**EFFECTS OF ASYMMETRIC LOCA LOADINGS**

**Supplement 1**

**Responses to NRC Questions**

**BAW-1621, Supp. 1**

Figure 2.13-1. Circumferential Pressure/Node Relationship for Skirt-Supported Plant (Figure C-2<sup>2</sup>)

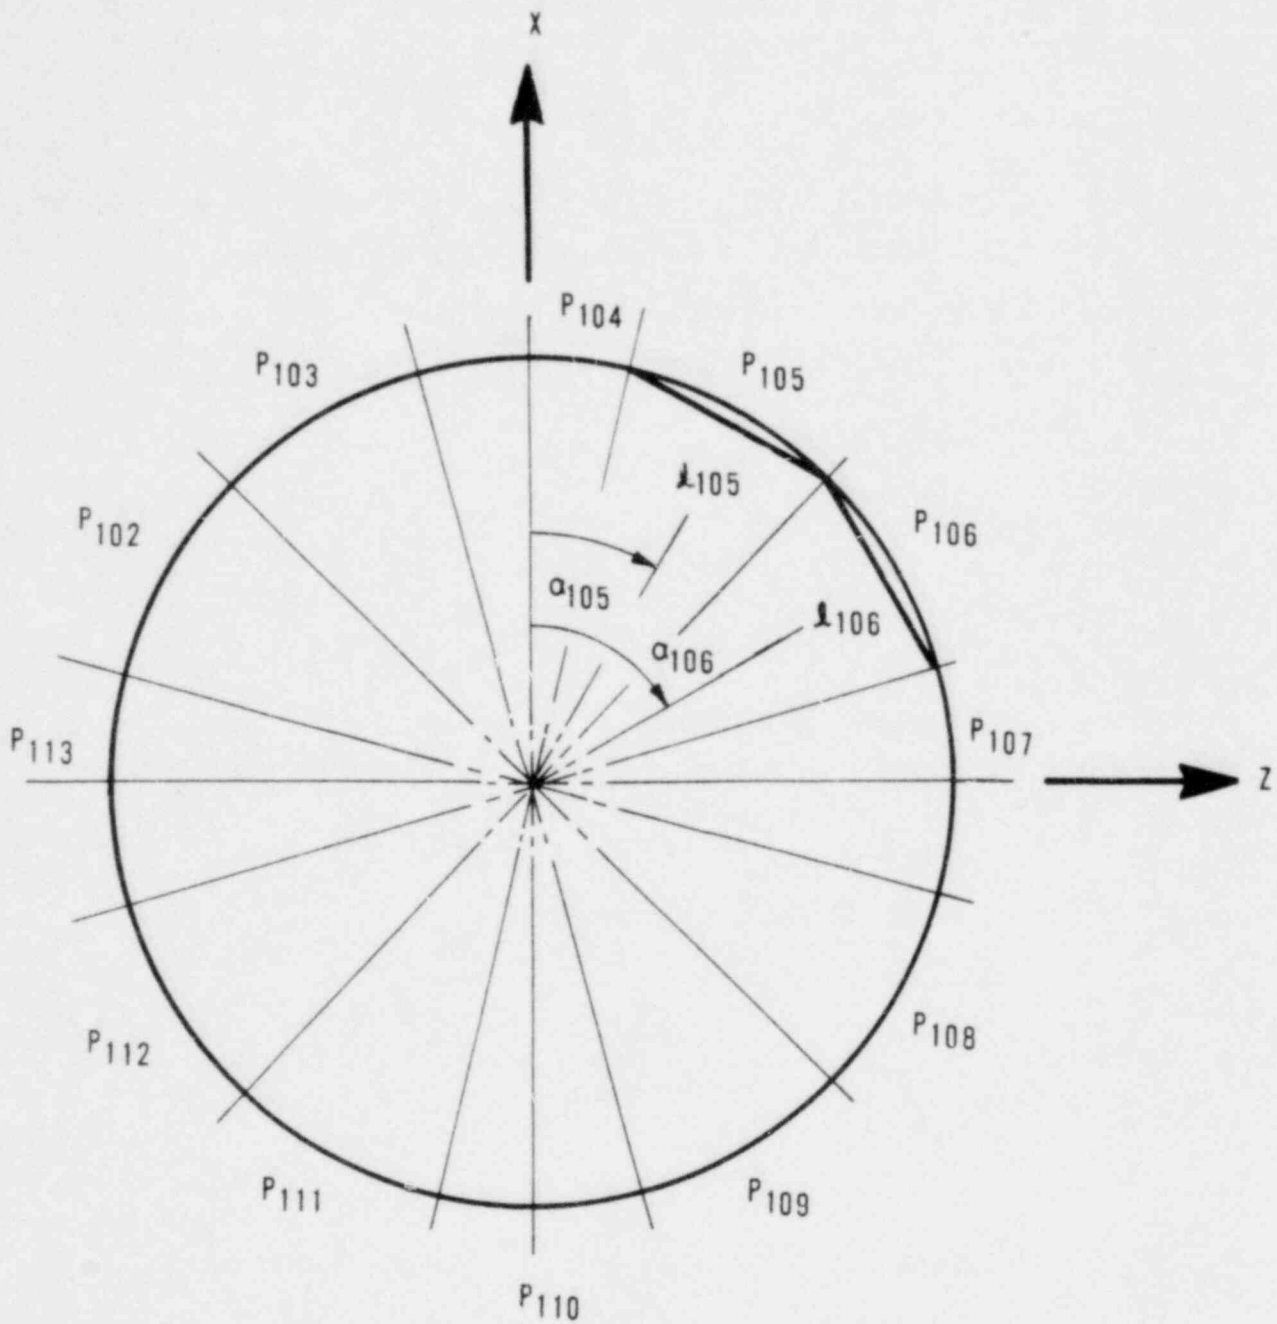
- 2.13. For the skirt-supported plant for a cold leg RV nozzle break, show a sample calculation for integrating the pressures around the core barrel periphery to get a directional force per unit length. Consider volume nodes 102 through 113 (at one elevation only) in Figures C-2 and C-3.

The equations used for force calculation of resultant horizontal components  $F_{xj}$  and  $F_{zj}$  (see Figure 2.13-1) are as follows:

Figure 2.20-1. CRAFT2 Noding Model for 177-FA Nozzle-Supported Plant - Elevation, Upper Plenum Region

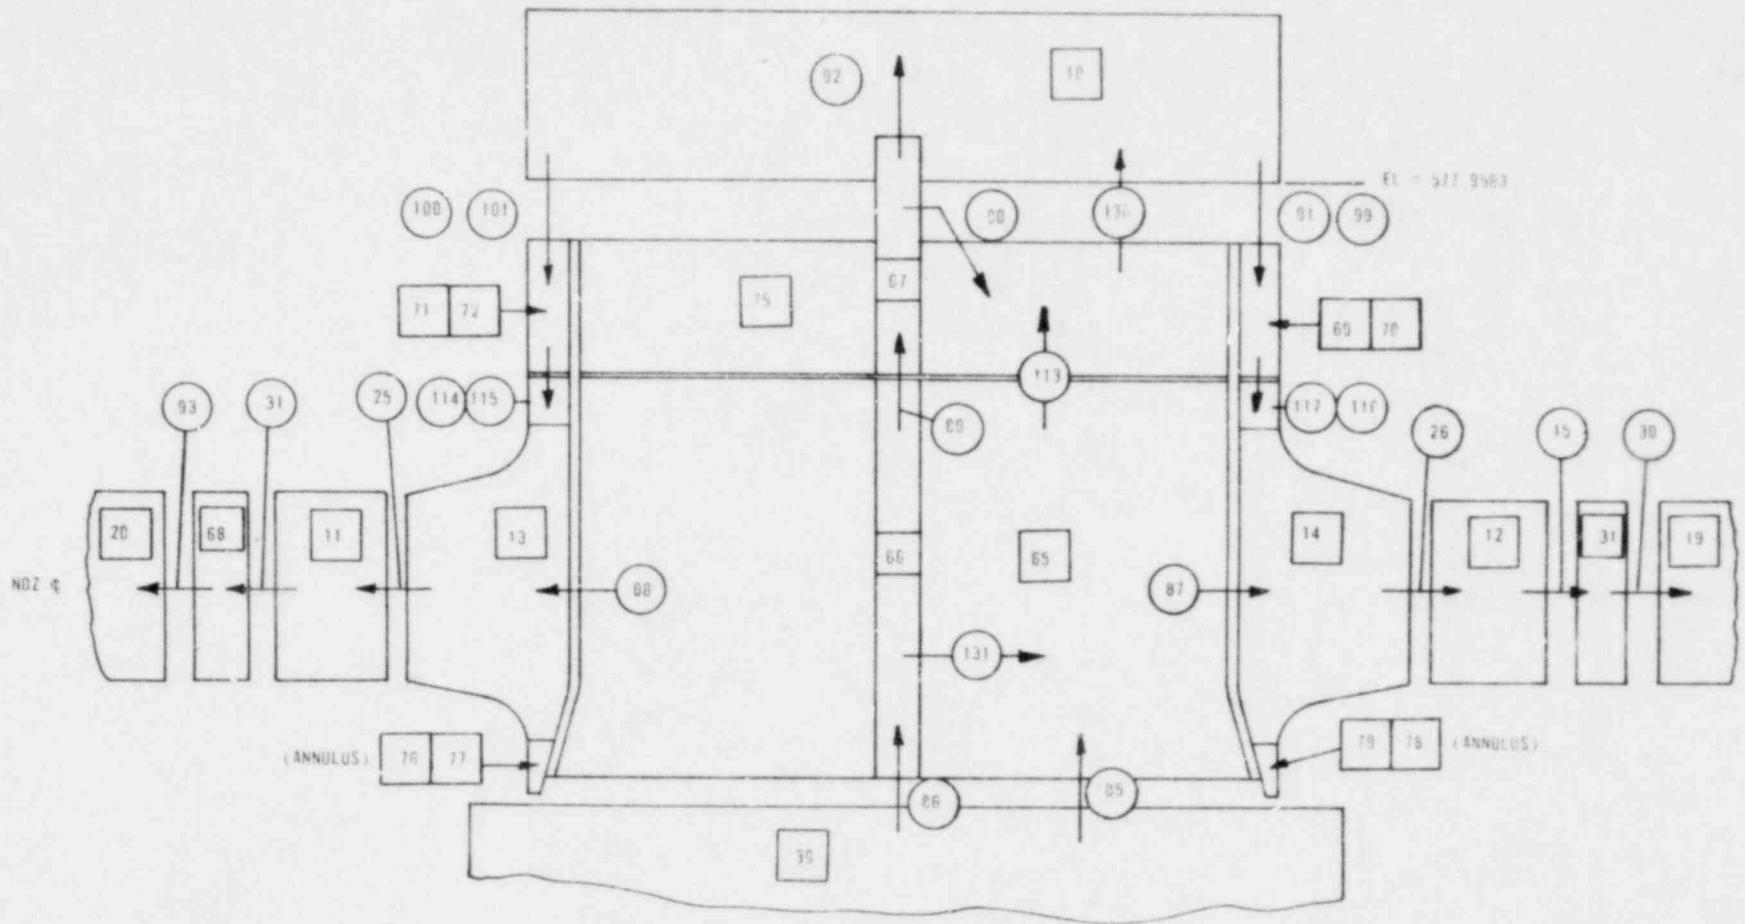
2.20. Figure C-11 is not interpretable. Provide a description, with legible volume node numbers, like Figures C-6 and C-7.

Figure C-11 has been divided into three parts -- Figures 2.20-1, 2.20-2, and 2.20-3 are attached. Description notes have not been provided since the nodes in the outlet annulus are divided into 90° sections.
